Re: Ancram PV LLC SUP-24-005 (SBL: 214-1-25.4)

Proposed Ancram Industrial Solar Facility

To: Town of Ancram Planning Board
From: Nan Stolzenburg FAICP
Date: February 28, 2025
Re: Ancram Solar (Miller) SUP and SPR Application

Site 4 Profile: Unobstructed View - 450 Woods Ct

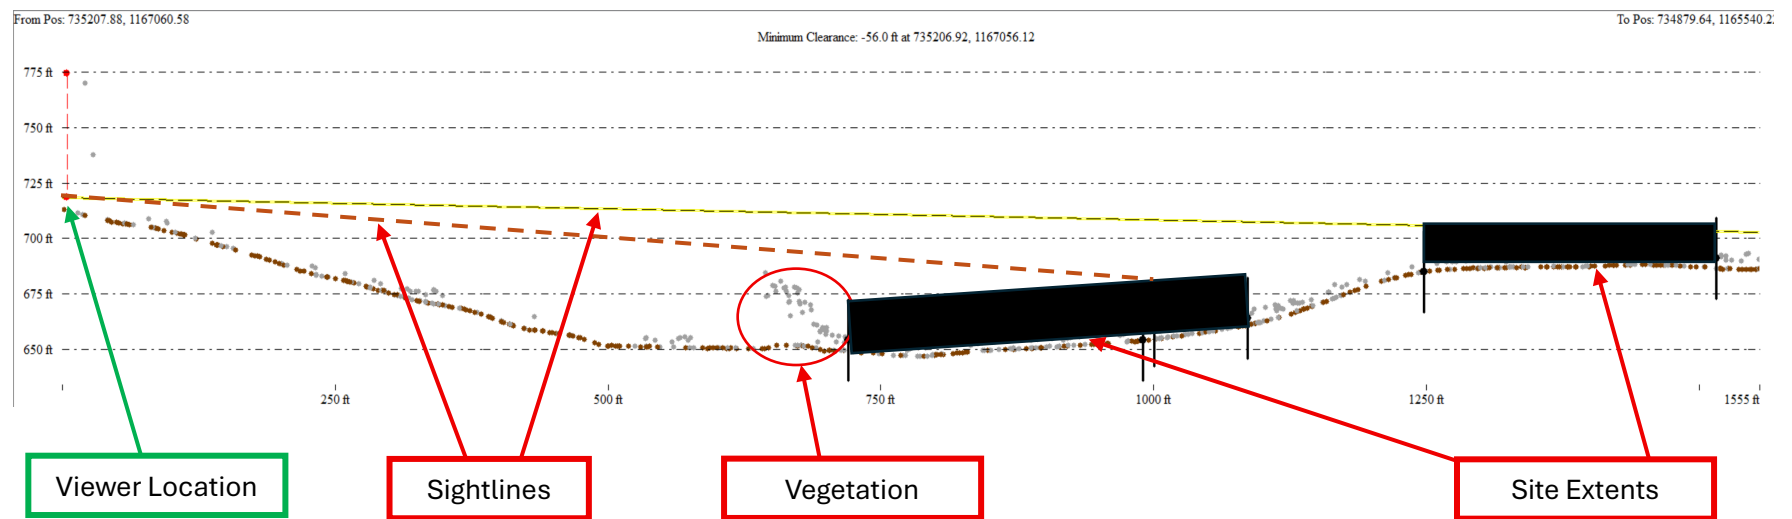
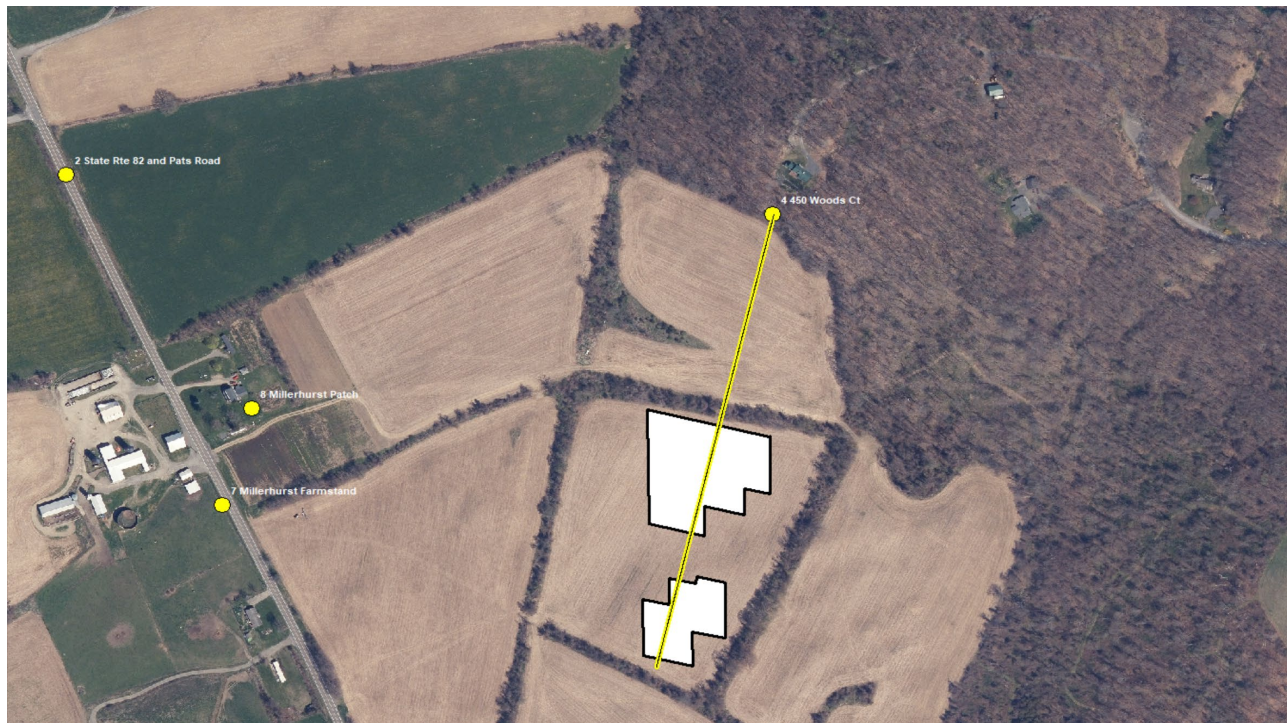
Rather than provide appropriate mitigation and screening, as required by the Solar Energy Law, the Applicant, instead, completely disavows any responsibility for impacting the views and value of the adjacent property. In its most recent submission, the Applicant wrote, "in New York State, there is no inherent legal right for a private landowner to maintain an uninterrupted viewshed across another property,"²⁸ which demonstrates a complete misunderstanding of the Applicant's obligation to follow local law requiring that the solar energy system be screened so as not to impact the view of residences such as 450 Woods Court, an existing residential dwelling on a contiguous property.

²⁷ See Harkin Viewshed Analysis, Appendix B, Site 4, attached as Exhibit A. *See also* photographs of the view of the project site from the backyard of 450 Woods Court, Attached as Exhibit C.
